Change Order

PROJECT: (Name and Address) Hidalgo County Precinct No. 1 1902 Joe Stephens Weslaco, TX 78596	CHANGE ORDER NUMBER: 01	OWNER ☒
	DATE: 5/8/2025	ARCHITECT ☒
	ARCHITECT'S PROJECT NO: 0001	CONTRACTOR ☒
CONTRACTOR: (Name and Address) NM Contracting, LLC. 2022 Orchid Ave McAllen, TX 78504	CONTRACT DATE: 10/15/2024	FIELD ☐
	CONTRACT FOR: New Wellness Activity Community Center (WACC)	OTHER ☒

Change Proposal Request	
Contract #	001
CPR #	2143.005R2
Issue Date	08-Apr-2025
Subject	OTIS elevator add as per Owner's Request, not previously on contract documents and required by TDLR.

Description of the proposed change:
OTIS elevator, structural changes, foundation changes.

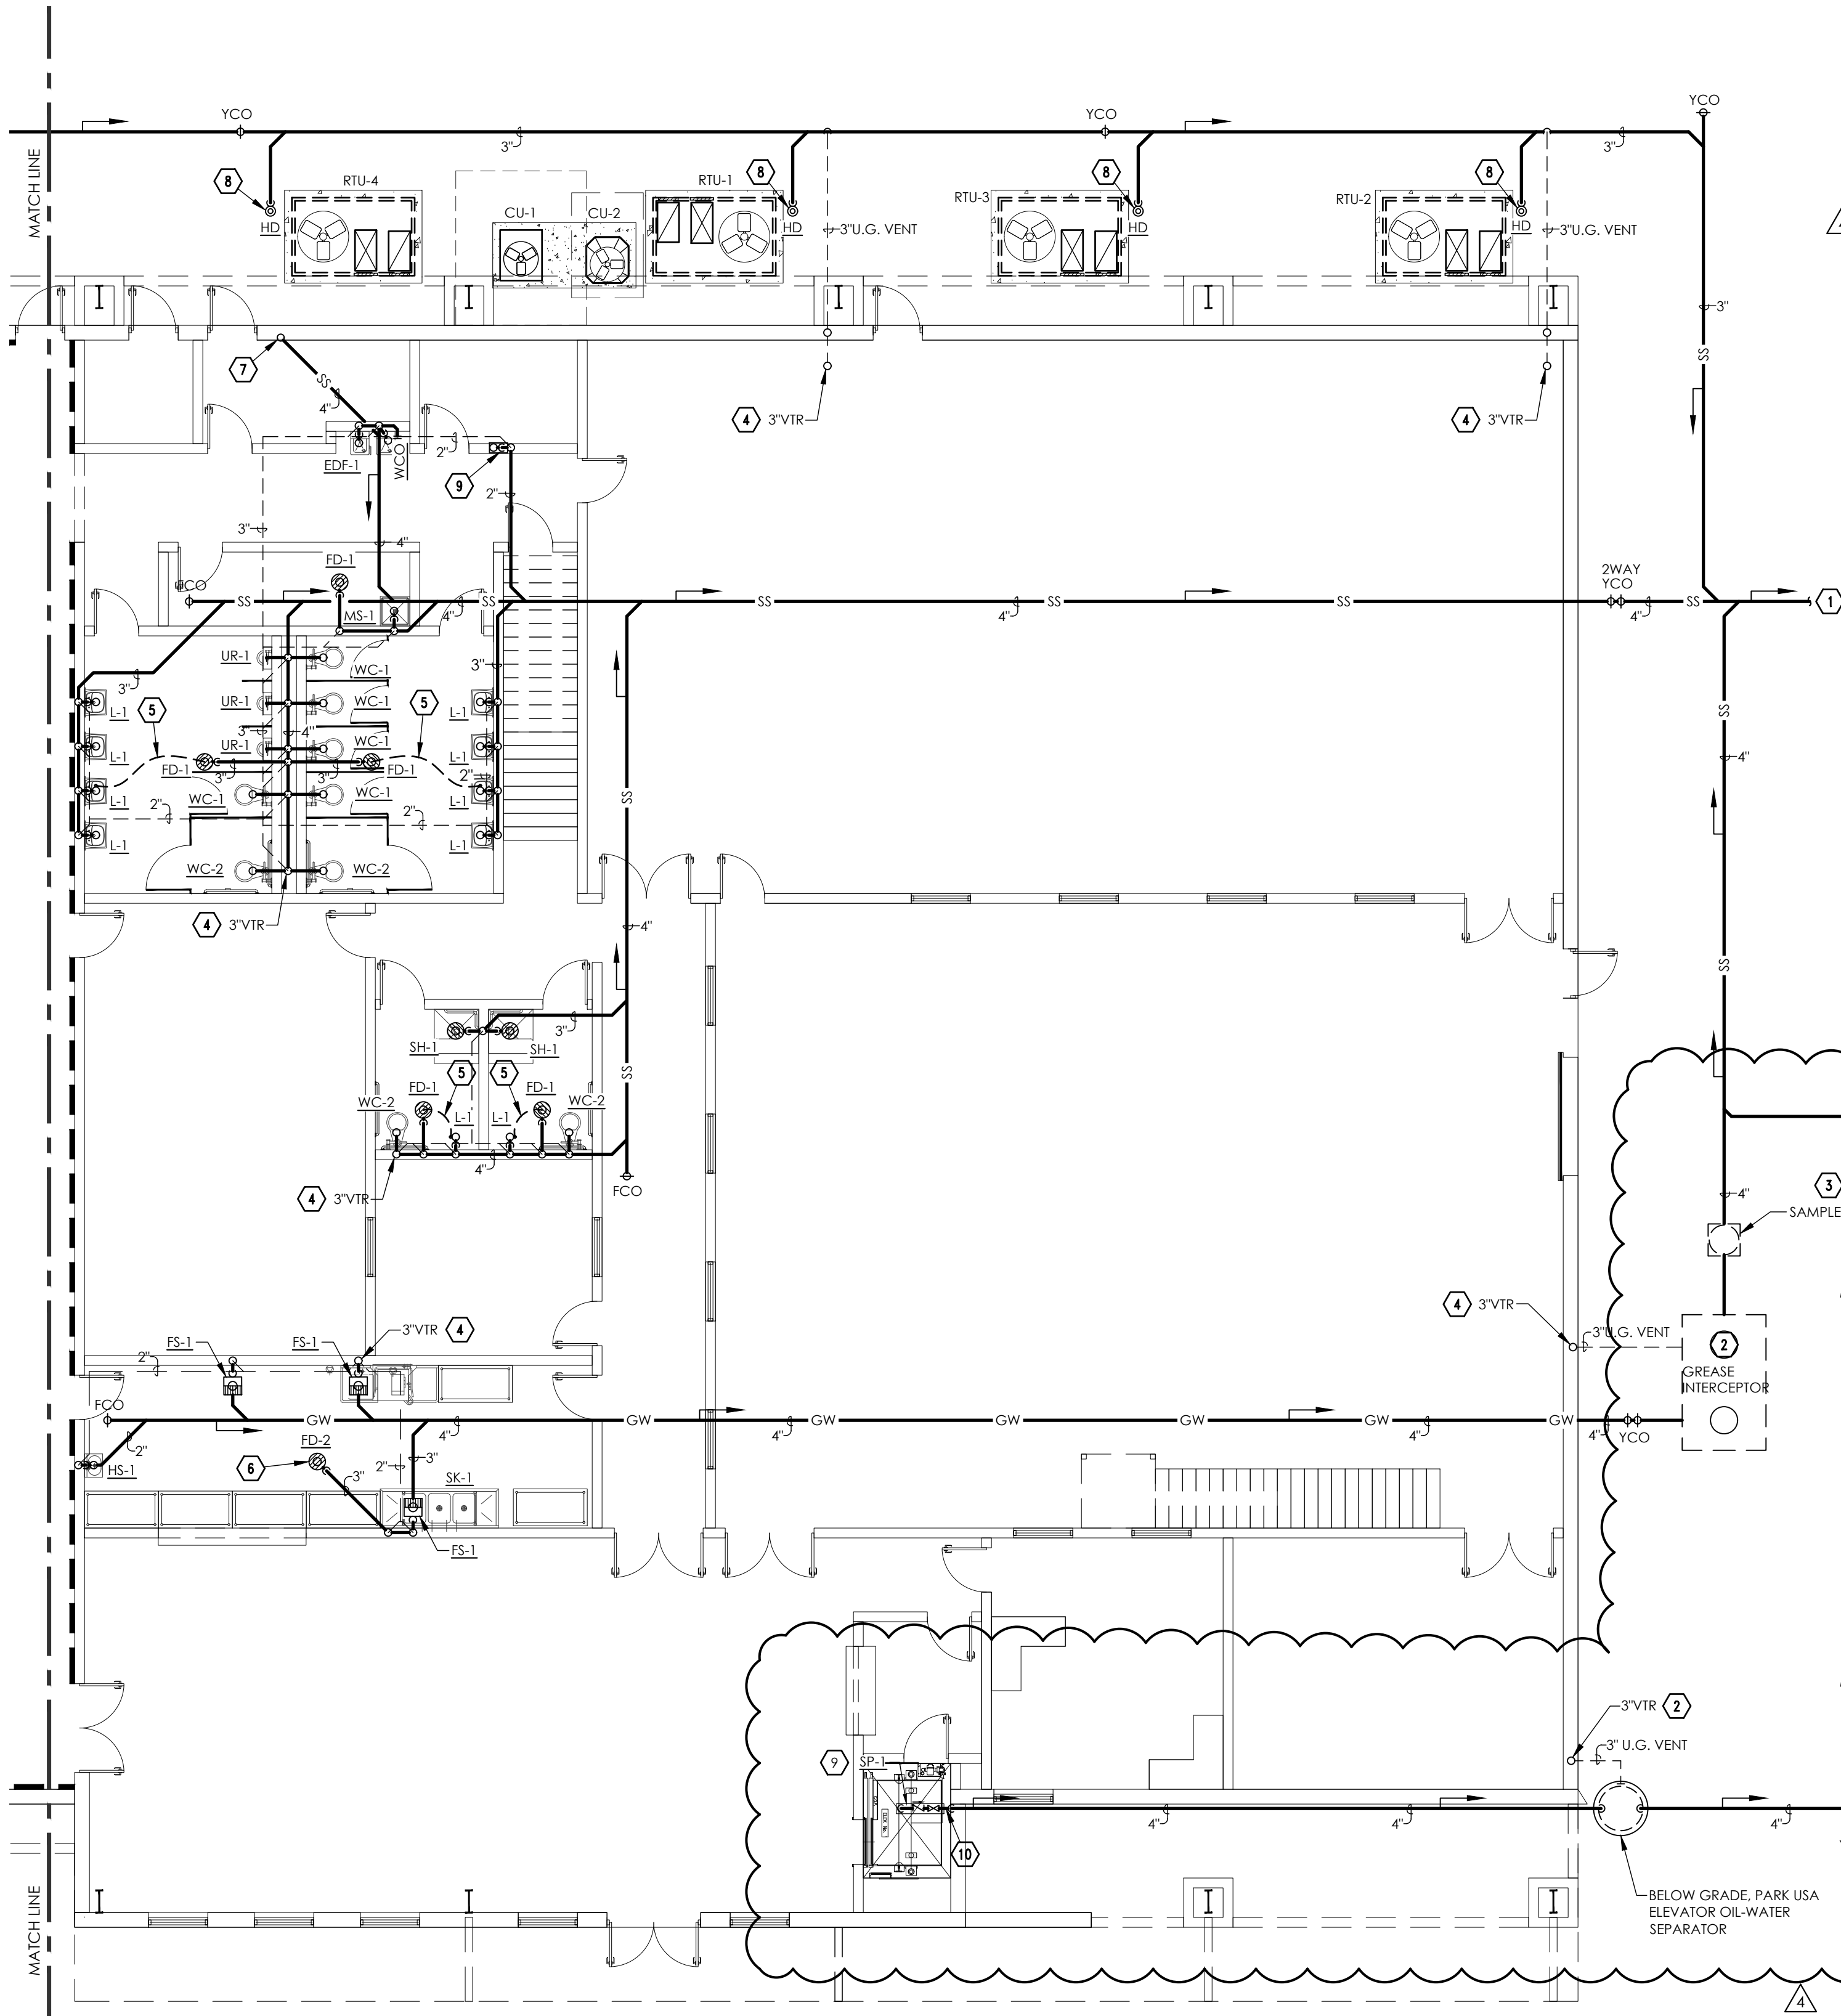
- 9 ParkUSA Elevator® ELEVATOR SUMP PUMP SYSTEM. SUMP PUMP .75hp. COORDINATE ELEVATOR SUMP PIT LOCATION WITH ELEVATOR CONTRACTOR. REFER TO MANUFACTURER'S DETAIL IN SHEET PD03.

PD02

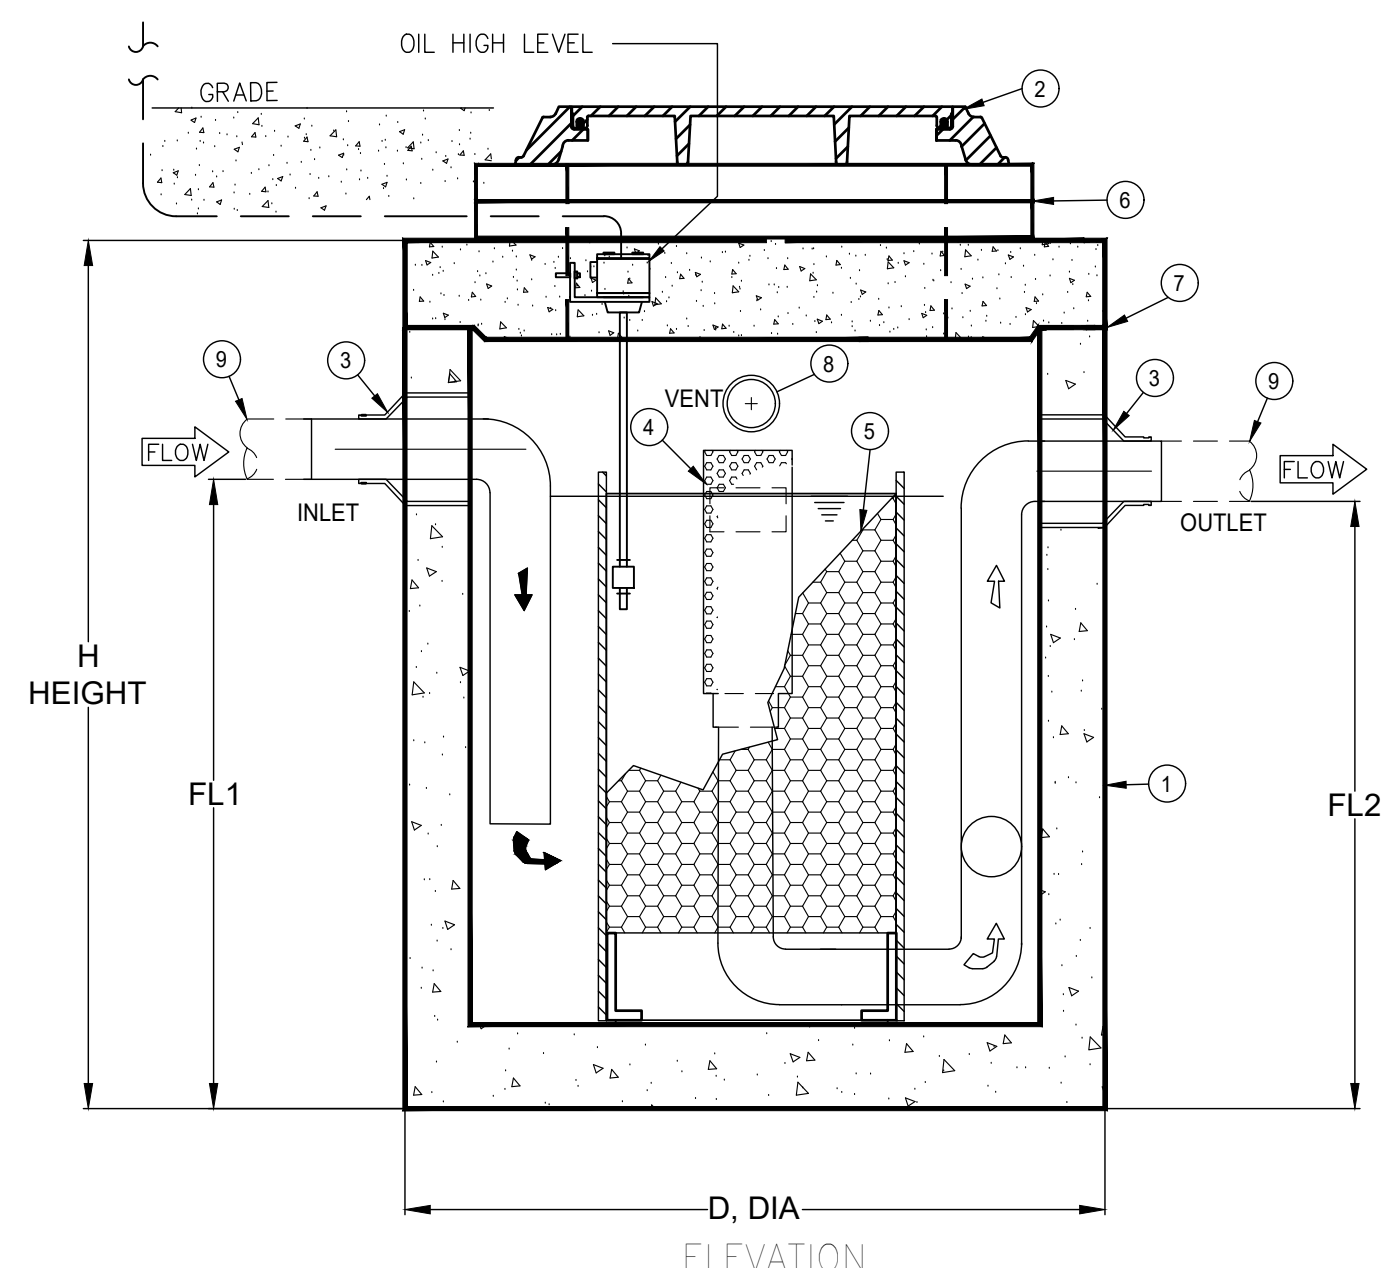
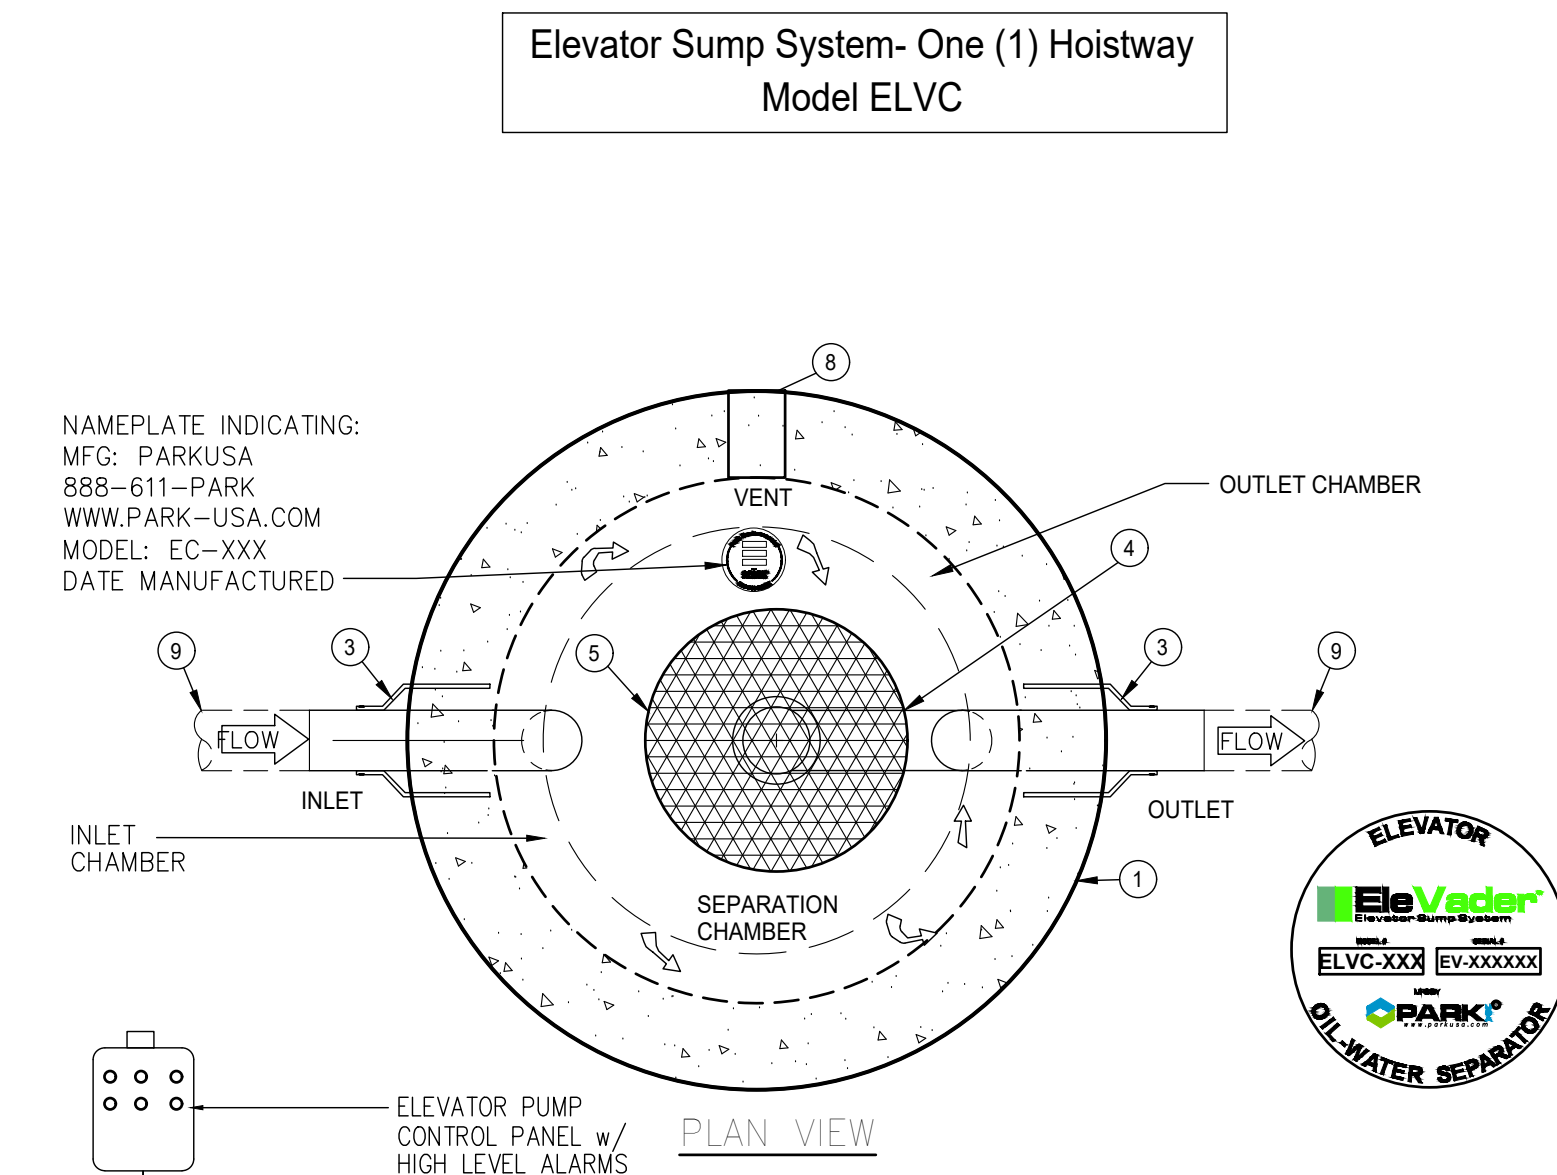
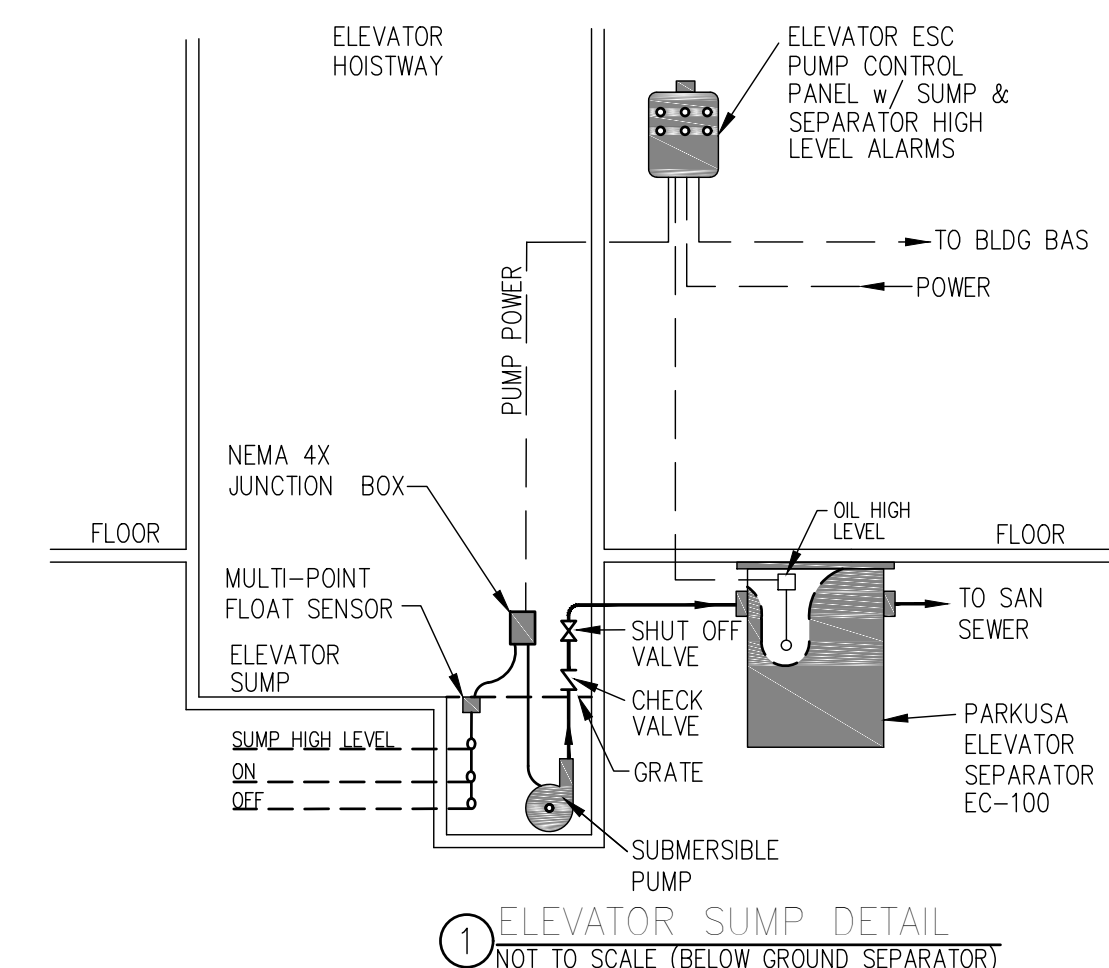
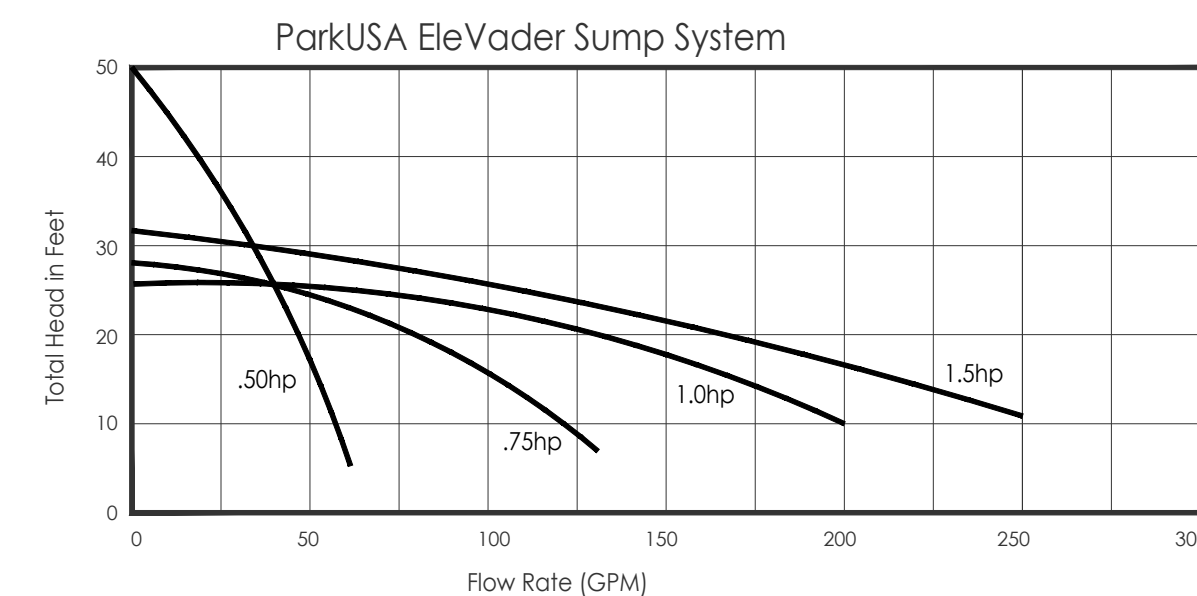
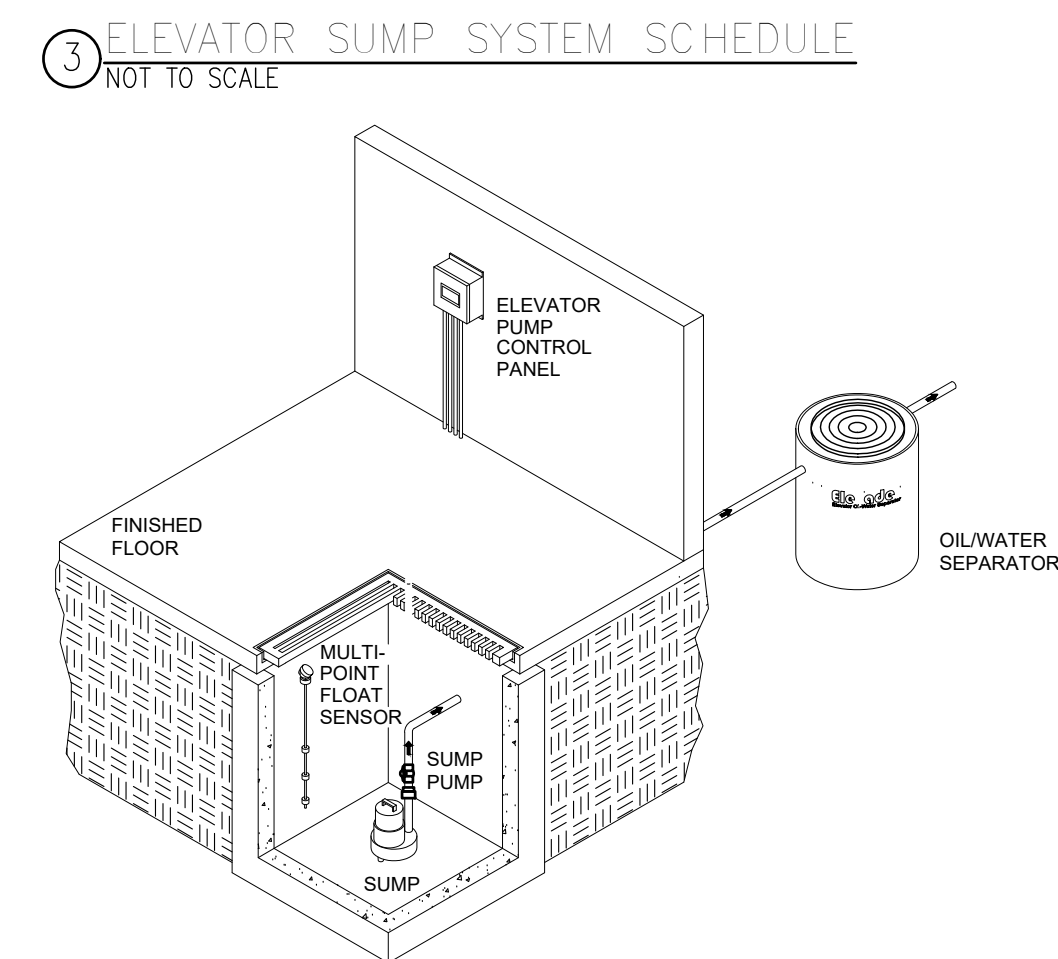
The system shall be capable of pumping all water & fluids automatically from the elevator pit as required by ASME A17.1/CSA B44 Safety Code for Elevators and Escalators, 2007, Section 2.2.2.5. The system shall function automatically to remove water and fluids from the pit automatically without any human intervention. Systems that do not remove all the fluid including oil are not compliant and will not be accepted.

A submersible sump pump is located in the sump area of the elevator (refer to plan drawings). The sump pump shall be as specified on the schedule, heavy duty submersible type, capable of pumping water, water/oil and oil at a minimum capacity of 50 GPM @ 20' TDH, (3000 GPH as per ASME A17.1 Section 2.2.2.5 (2007) and 100 GPM @ 20'TD'H. The pump shall be constructed and tested to meet UL 778 standards and shall include thermal overload protection. Refer to the schedule for capacity and electrical requirements. The pump shall be capable of operating with the water level covering only 50% of the motor casing and shall operate automatically either continuously or intermittently as required by the on-off float switch control. The pump shall have a size 1-1/4" minimum discharge connection. The motor housing and fastening bolts shall be constructed of 304 Stainless Steel and have carbon ceramic seals. The pump shall have a semi-open, non-clogging vortex impeller and shall be designed for floor mounting complete with support legs. A stainless chain shall be provided for easy maintenance.
